CITY OF LABELLE, FLORIDA
Staff Report
For SR80 Commercial PUD
Commission Review Tree Removal

TYPE OF CASE: Tree Removal Permit Requiring City Commission Approval

DATE: March 12, 2026

EXHIBIT A SIGNIFICANT OAK TREE SURVEY

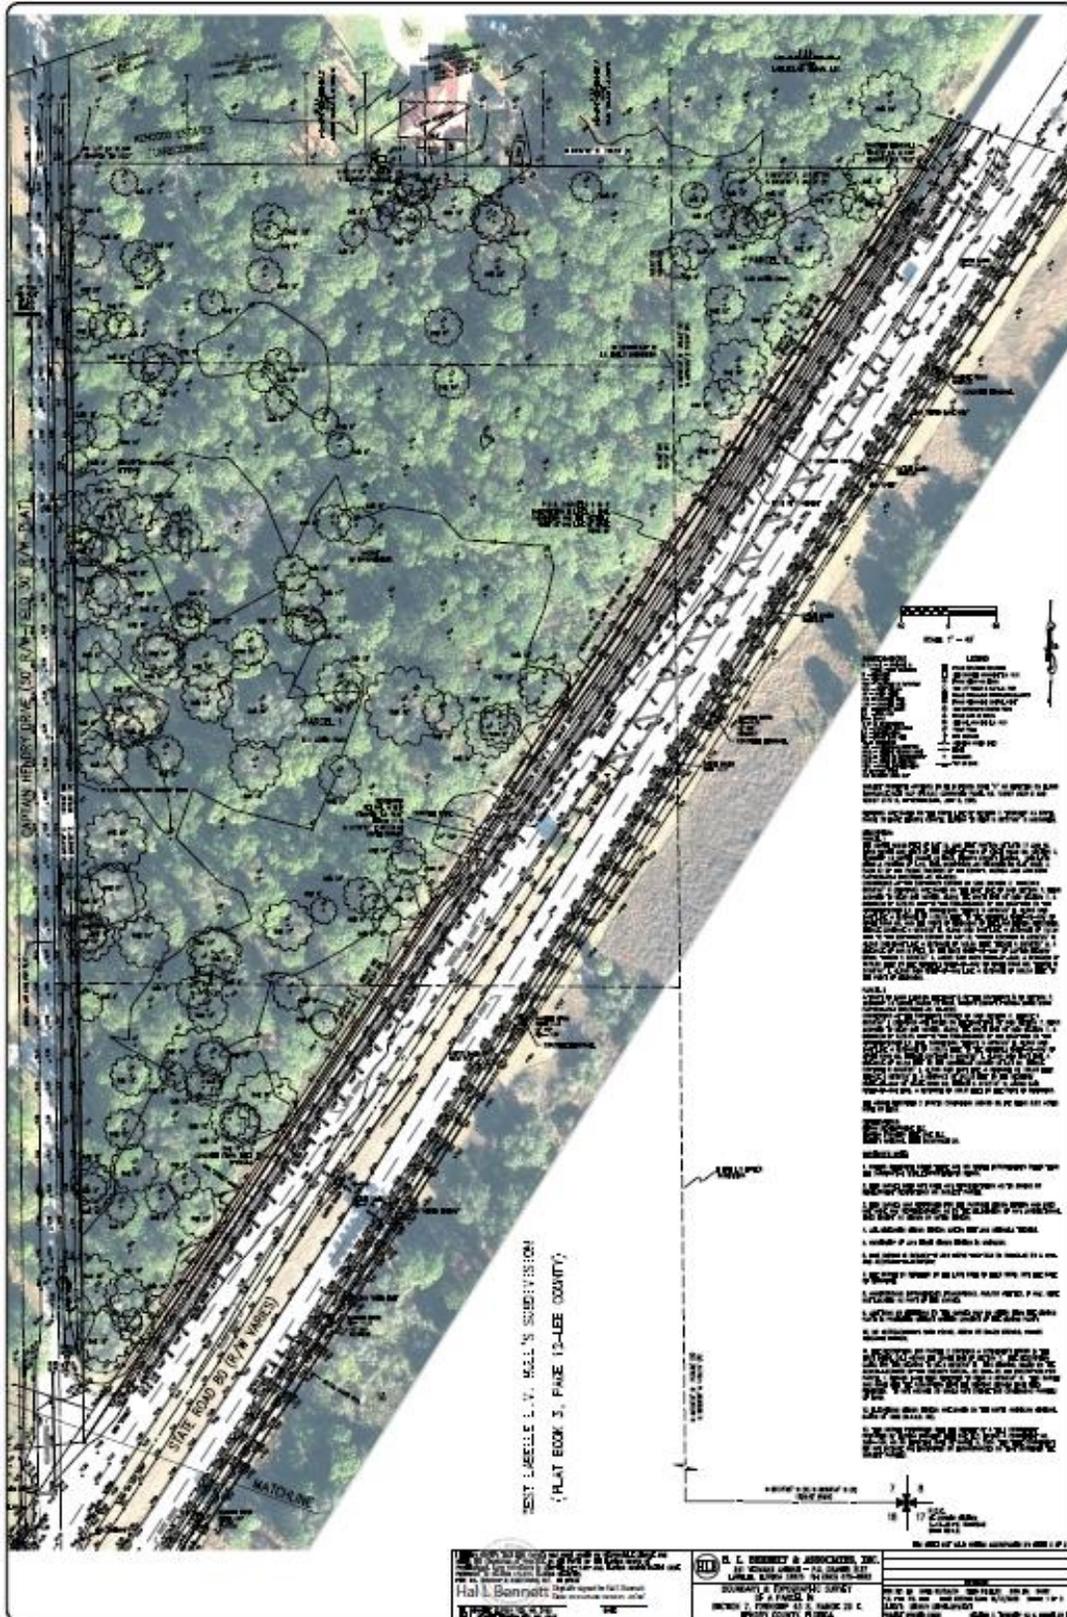
To offset the loss of these significant trees, the applicant proposes partial on-site mitigation through the planting of 165 Live Oak trees, totaling 660 inches towards the required mitigation. This results in a deficit of 324 caliper inches. While a payment-in-lieu was not proposed by the applicant, the resulting payment would be \$48,600 (\$150 per inch).

While these constraints are acknowledged, staff notes that development-related conflicts alone do not eliminate the requirement for full mitigation under Section 4-80.16.5, and preservation of Significant Oak Trees remains a priority under the City's Land Development Code. Staff finds the request is inconsistent with the LDC due to the 324 caliper inch deficit without mitigation or payment-in-lieu outlined LDC Section 4-80.16.5.6.

I make a motion to approve the proposed tree removal permit, subject to the on-site replanting or payment-in-lieu for the total of 984 inches of live oaks trees, meeting the minimum size specifications of the Land Development Code.
